Hill Crest Estates Replat A

City of El Paso — City Plan Commission — 10/18/2018

SUSU18-00062 — Resubdivision Preliminary

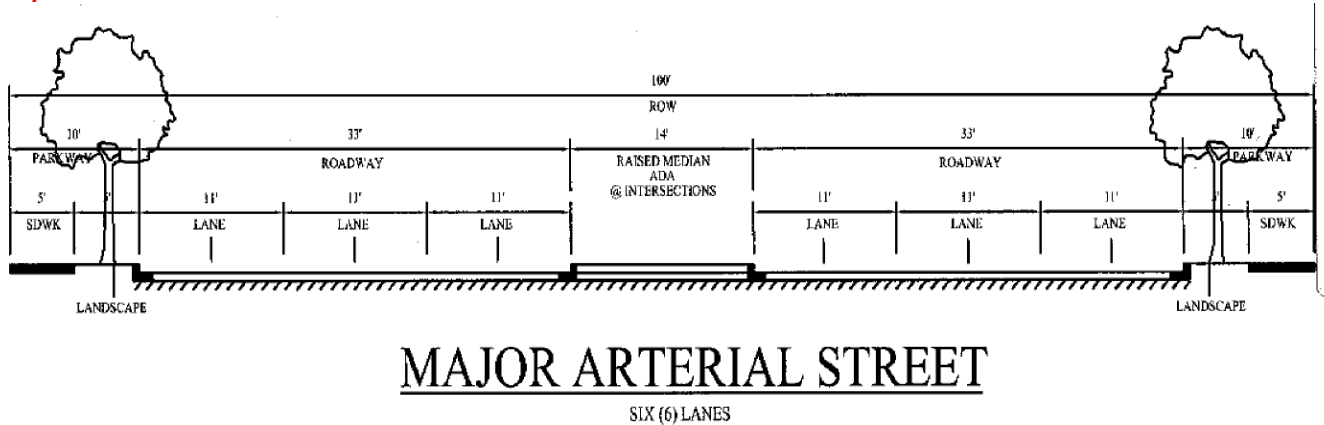
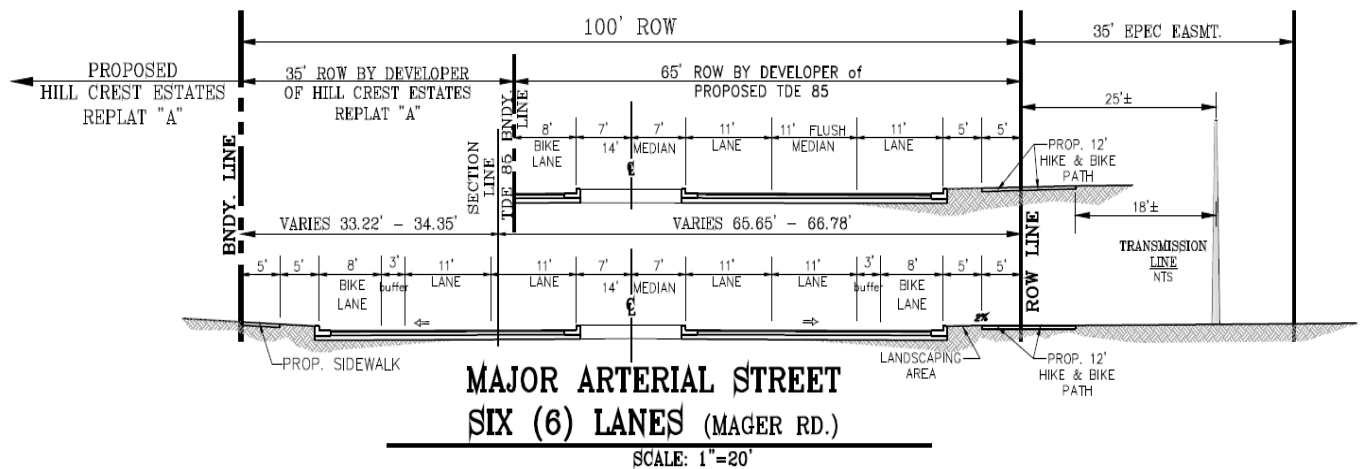
1: The applicant is requesting an Alternative Design for the proposed cross-section for Mager Road as per 19.26.040 – Alternative subdivision improvement design.

- Per the DSC, a major arterial requires a 14' median, 33' roadway consisting of three 11' driving lanes, and a 10' parkway consisting of a 5' landscape buffer and a 5' sidewalk.
- The applicant proposes a 14' median, 33' roadway consisting of two 11' driving lanes, an 8' bike lane with a 3' buffer, and a 10' parkway consisting of a 5' landscape and a 5' sidewalk..

- 1: Streets & Maintenance recommends a 7' bike lane with a 4' buffer rather than the proposed 8' bike lane and 3' buffer.

ATTACHMENT 2

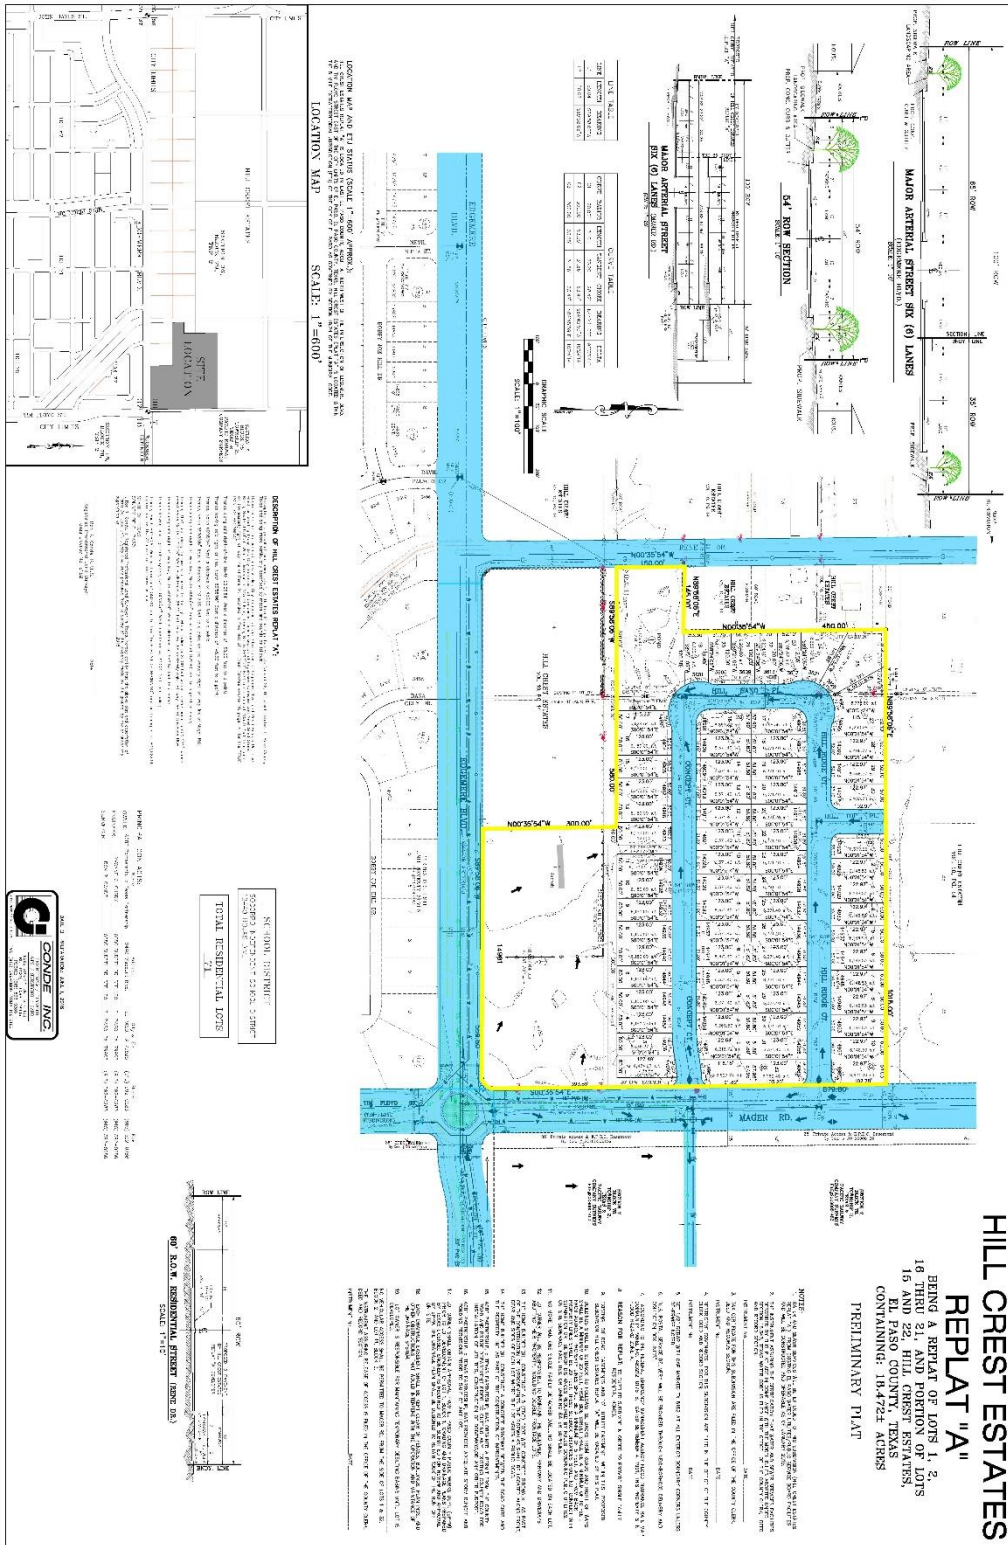
- 1: Applicant needs to propose how 60' wide road easements that straddle the property lines will be vacated, especially the southern boundary of the subdivision where the adjacent properties appear to be utilizing the road easement to access the rear of their property.
- 2: As presented, the applicant will need to request a variance request from Commissioners Court for the ROW width.
- 3: County may opt to accept escrow for the improvements on Rene Drive, in lieu of constructing the small section of roadway.
- 4: North of Concept Court (Street A), Mager Road is proposed to have two-way traffic on the eastern half of the arterial road. Applicant may need to construct Mager extension to the north, beyond subdivision boundary limits, to provide traffic transition.

- 1: Proposed pond shall have enough capacity to hold the developed runoff for a designed 100-year storm event. Identify other properties outside of the subdivision if they are to discharge into this pond.
- 2: At the improvement plan stage, protect the subject property from stormwater runoff from the adjacent terrain.

- 1: Recommend landscape arterial parkway as per Subdivision Ordinance.
- 2: Recommend annexation of northern Edgemere Blvd. limits to avoid having Edgemere Blvd. under two jurisdictions and maintenance responsibilities.

- 3: Also clarify the difference proposed Mager Rd. street cross sections as illustrated.
- 4: Illustrate required / proposed bike lanes, improvements on Edgemere Blvd.

- 5: Are there are additional ROW requirements at the southeast subdivision corner for the round-about pedestrian elements.
- 6: Clarify if the 30 foot road easement extends through Block 1, Lot 1, of the proposed subdivision, and will it remain or be vacated?

- 7: Clarify if the 60 foot road easement extends through Block 1, Block 2, and multi lots within the proposed subdivision, and will it remain or be vacated?

- 8: Clarify if the 30 foot road easement extends through Block 1, multi lots at the northern boundary of the proposed subdivision, and will it remain or be vacated?
